June 9, 2014
Project No. 1998

RE: NEW BEDFORD-LOGAL LLC
DEP File No. SE 049-0702 - Response to Notice of Intent (NOI) Review Comments
100 Duchaine Boulevard

Field Engineering Co., Inc. has received the NOI review comment letter dated June 2, 2014 prepared by Nitsch Engineering and has prepared the following response narrative and supporting documentation for consideration by the Commission.

PLAN VIEW OF TYPICAL APRON CORNER AND GROOVE SPACING DETAIL

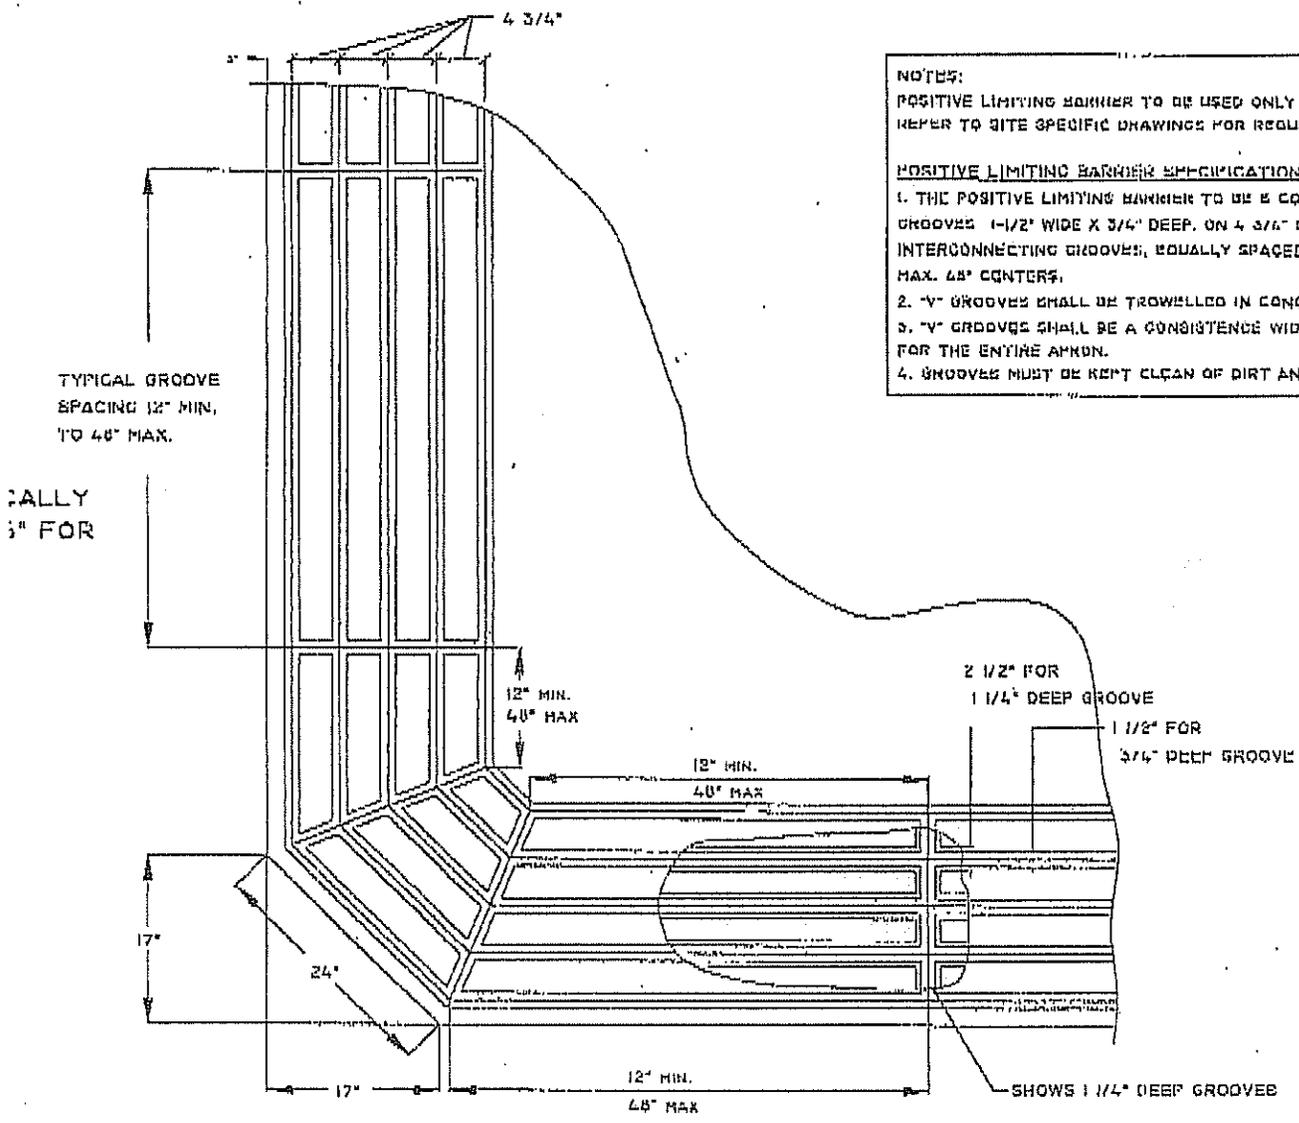
- 2.a. Additional information on the fueling facility layout and design has been included on the site plans and shop cuts of the proposed fuel storage tank are included with this response letter. The above ground storage tank will be a double walled tank with leak detection within the secondary containment envelope of the tank. An additional concrete pad has been proposed where vehicles will park during fueling to minimize the chance for infiltration of the fuel into the ground due to a spill. This concrete pad will be level and equipped with notches cut into the concrete to retain any minor spills that could potentially occur during refueling. The notches have been sized and designed to retain approximately 15 gallons of fuel should a spill occur while fueling.
